Release Note

Edgecore EAP102 Release v12.4.1

Document # EAP102-v12.4.1-1039-c32b0269

Enhancement from v12.4.0-971-24746b8b

1.2 User Account Enhancement

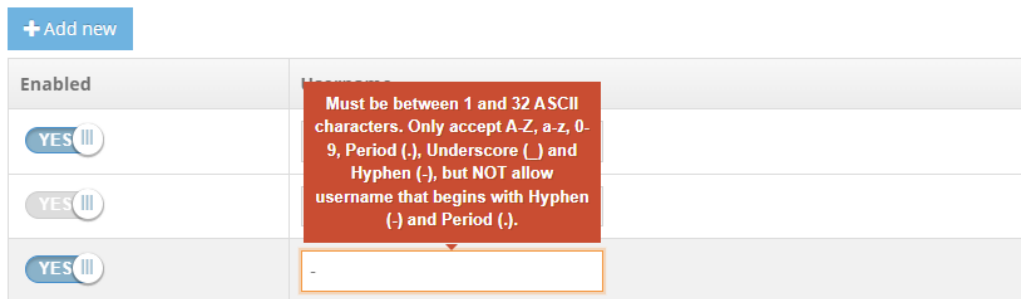
Add the validation for user accounts below.

1. Username - Must be between 1 and 32 ASCII characters. Only accept A-Z, a-z, 0-9, Period (.), Underscore (_) and Hyphen (-), but not allow username that begins with Hyphen (-) and Period (.)
